SITE PLAN & ARCHITECTURAL COMMISSION AGENDA NOVEMBER 16, 2018

STAFF REPORT

Project 1120 Helicopter Way Development
Applicant: Mark Courtney; Agent: ZCS Engineering Architecture

File no. AC-18-128

PROPOSED
CIVIL SITE PLAN
C1.0

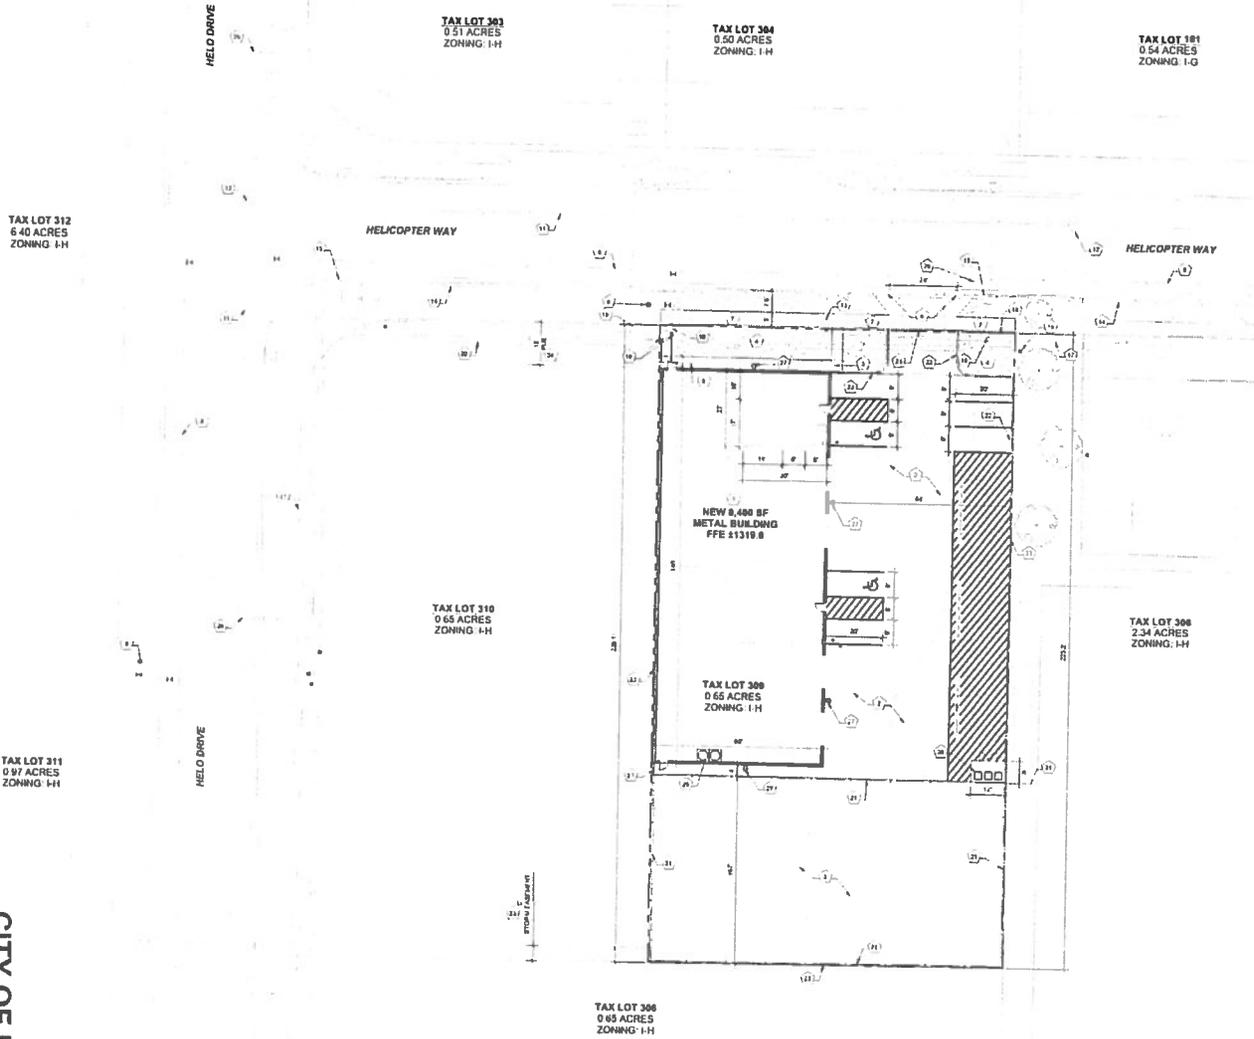
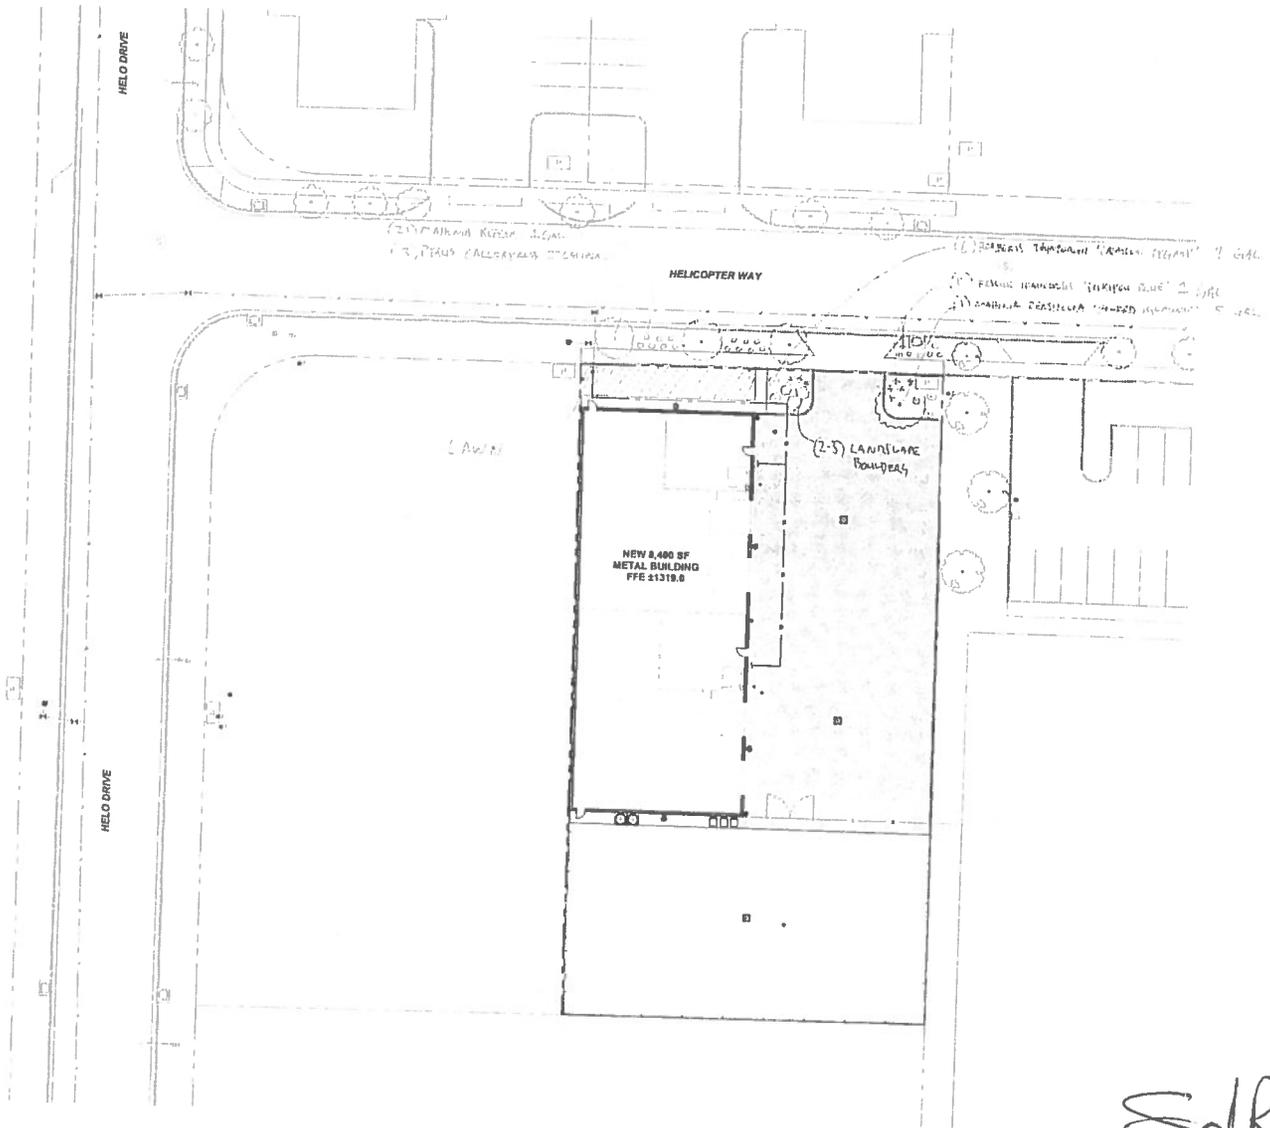
The property has frontage on Helicopter Way. Standard street section improvements have been completed with the exception of the five foot sidewalk and eight foot planter strip. Per the applicant's site plan (Exhibit B), a seven and a half foot planter strip and five foot sidewalk will be included. The Public Works report (Exhibit G), states that an eight foot planter strip is required. A condition has been included to submit a site plan with an eight foot planter strip prior to vertical construction permits being issued.

The site plan and findings do not address bicycle parking. Per the MLDC Section 10.748 a minimum of two bicycle parking spaces are required. A condition of approval has been included requiring compliance with 10.748.

The applicant is proposing a four foot wide pedestrian sidewalk connecting the public sidewalk to the proposed building. Per MLDC 10.775 the walkway is required to be a minimum of five feet in paved unobstructed width. A condition of approval has been included requiring compliance with 10.775.

Standard street section improvements have been completed on **Helicopter Way**, including pavement, curb and gutter, street lights and partial sidewalk as part of the Hover Heights (P1435D) improvements. **No additional street improvements are required, except for 5-foot wide sidewalk with an 8-foot planter strip.**

- **Helicopter Way** – No improvements are required aside from 5-foot wide sidewalk and 8-foot planter strip.

1. AC-18-128
 Applicant: Mark Courtney

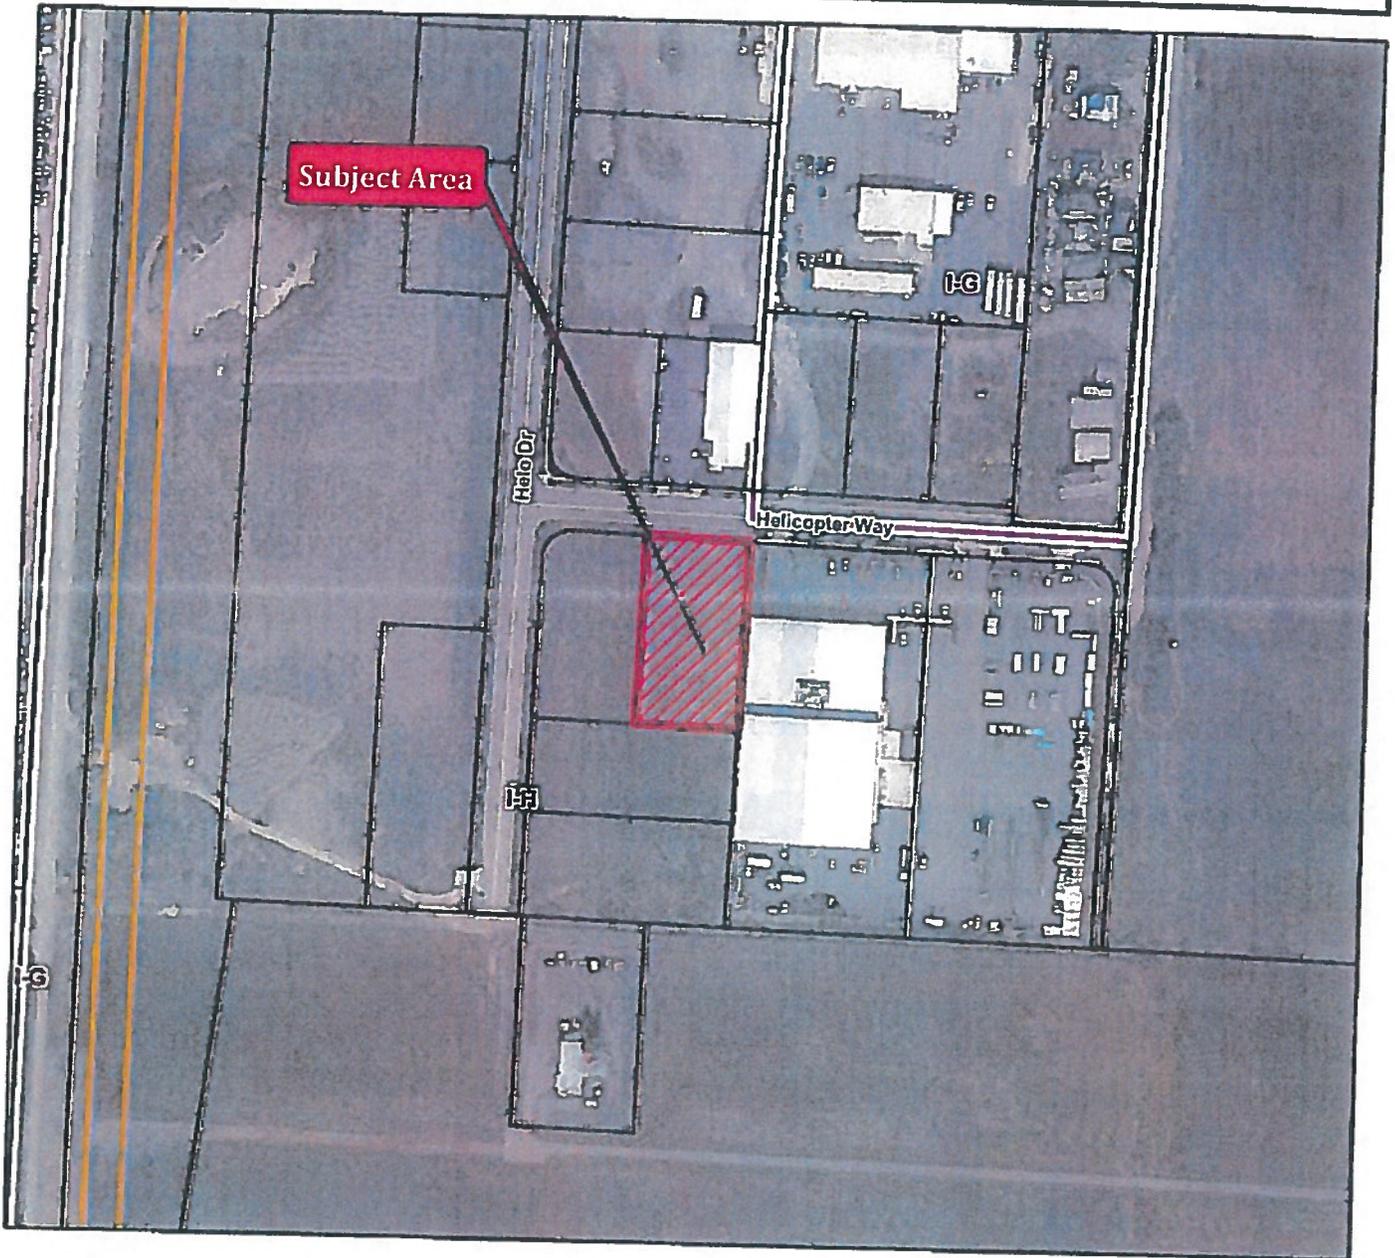
~~No. comments, Jon 10/15/18~~
 Description is a lawfully created lot
 & describes the area depicted on
 vicinity map attached.
 Jon 10/15/18
